TECHNISCHE INFORMATION NR. SI 36-055

SERVICE INFORMATION NO. SI 36-055

ATA Code: 34-00
GARMIN Software Service Bulletin No.:
0846 Revision B

TO: All Garmin Aviation Service Centers
DATE: 10 March 2009
SUBJECT: GTX 330/330D and GTX 33/33D Software Version 6.00 Non-G1000/G900X/GNS 480 Applications Only
REVISION B: Added note for GNS 480 Installations

Figure 1

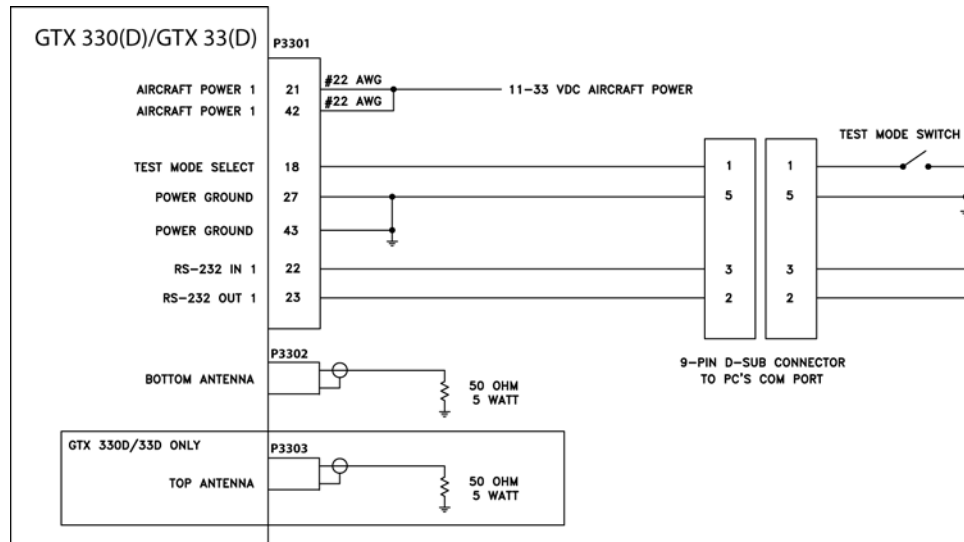
1. Use a test harness as shown in Figure 1.

If the unit is removed from the aircraft and operated, always connect J3302 (GTX 330/GTX 33) and J3303 (GTX 330D/GTX 33D) to a 50 Ω , 5-watt load. The GTX transmits Mode S acquisition squitter replies once per second whether interrogations are received or not. Failure to connect a dummy load or antenna during this procedure will cause the transponder to fail.

2. Ensure the unit is turned off. Connect the GTX to the test harness and apply power to the harness.
3. With the unit off, enable test mode via the Test Mode Switch. (Applies a ground to P3301 pin 18).
